Access Compliance Report Public Rights-of-Way (Curb Ramps)

Main Street: KITTRICK_DR Cross Street: FOSTER_RD Location: S

ADA ID: RPAT211202085448 Ramp Type: Type 1 - Perpendicular Diagonal Initial Pass/Fail: Fail Overall Compliance: No Severity Score: 16

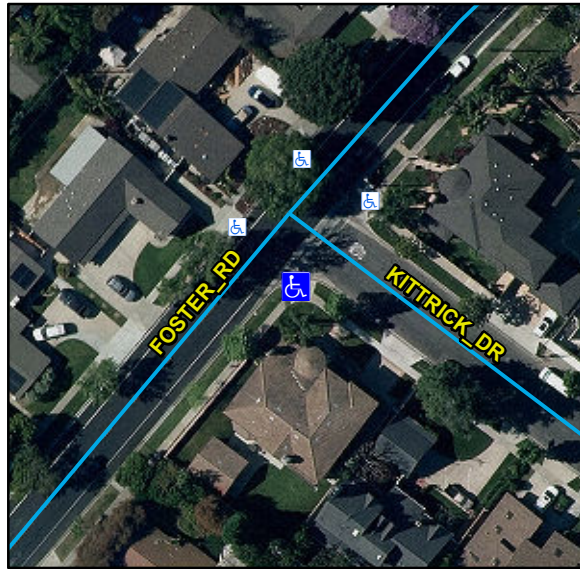
Compliance	Description	Data	Compliance	Description	Data
N/A	Ramp Length (in)	82	N/A	Flare Type LT	
Yes	Ramp Width (in)	48			N/A
No	Ramp Run Slope (%)	9	N/A	Flare Slope LT (%)	N/A
No	Ramp Cross Slope (%)	2.8	N/A	Flare Traversable LT	N/A
N/A	Landing Present	N/A	N/A	Flare Type RT	
N/A	Landing Length (in)	N/A			N/A
N/A	Landing Width (in)	N/A	N/A	Flare Slope RT (%)	N/A
N/A	Landing Run Slope (%)	N/A	N/A	Flare Traversable RT	N/A
N/A	Landing Cross Slope (%)	N/A	N/A	DWS Provided	N/A
N/A	Landing Movement Obstructed?	N/A	N/A	DWS Contrast	N/A
	Landing Movement Type	N/A	N/A	DWS Length (in)	N/A
N/A	Landing Shared	N/A	N/A	DWS Full Width	N/A
N/A	Clear Space	Yes	N/A	DWS Offset Left (in)	N/A
N/A	Clear Space To Crosswalk (in)	N/A	N/A	DWS Offset Right (in)	N/A
N/A	Marked Crosswalk 1	No	N/A	Marked Crosswalk 2	No
	Crossing 1 Direction	NE		Crossing 2 Direction	NW
	Marked Crosswalk 1 Width (in)	N/A		Marked Crosswalk 2 Width (in)	N/A

N/A	Ramp Inside Crosswalk 1	N/A	Yes	Ramp Inside Crosswalk 2	N/A
	Crossing 1 Slope (%)	3.3		Crossing 2 Slope (%)	6
	Crossing 1 Cross Slope (%)	1.8		Crossing 2 Cross Slope (%)	0.6
N/A	Gutter Ponding	N/A	No	Curb Slope	9.2
Yes	Gutter Lip Height (in)	0		Road Run Slope (%)	0.2
N/A	Gutter Run Slope (%)	N/A		Road Cross Slope (%)	0.8
N/A	Gutter Cross Slope (%)	N/A			
Yes	Overall Surface Condition: Acceptable		No	Perp Joint Present	No
	Cross Gutter Present?	Yes		Spandrel Present?	Yes
	Replace Cross Gutter?	No		Replace Spandrel?	No

Remove & Replace Curb Ramp With Two New Directional Ramps or Equivalent.

R304.2.2, R204.3, R304.5.3, STD 1115
